SOUTH ACCESS TO THE GOLDEN GATE BRIDGE

DOYLE DRIVE

Doyle Drive Project
Final Environmental Impact Statement/Report
and Final Section 4(f) Evaluation

EXHIBIT 2-1
Preferred Alternative – Refined Presidio Parkway

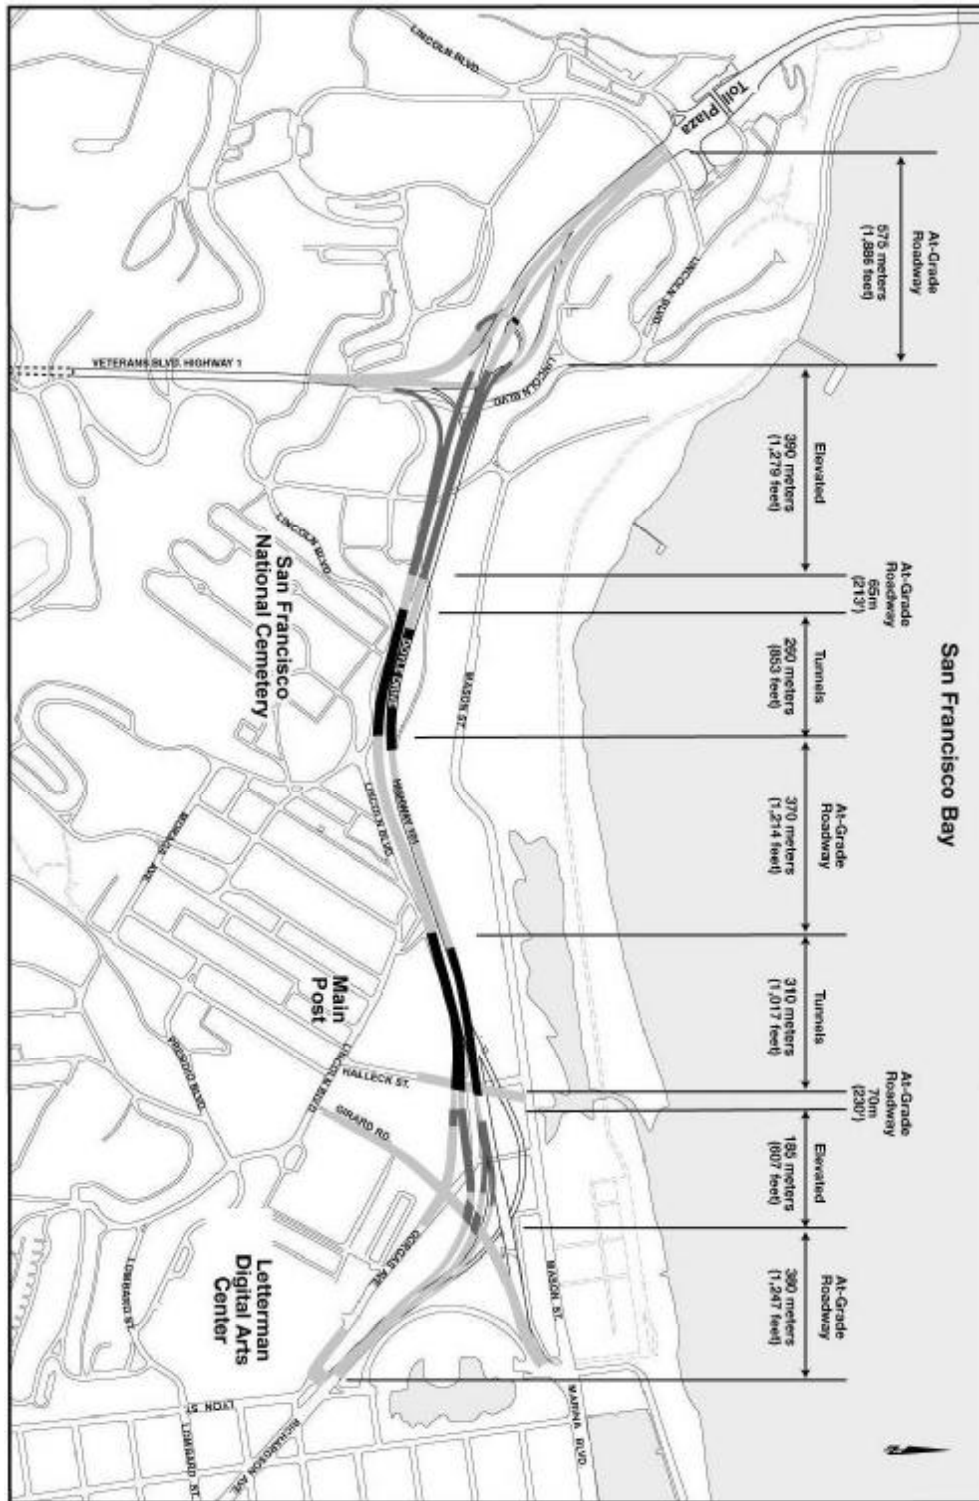
Page 2-2 - Please revise Exhibit 2-1 to show the Toll Plaza area extending south to just north of Lincoln Blvd. The Merchant Rd. ramps are located within the Toll Plaza area.
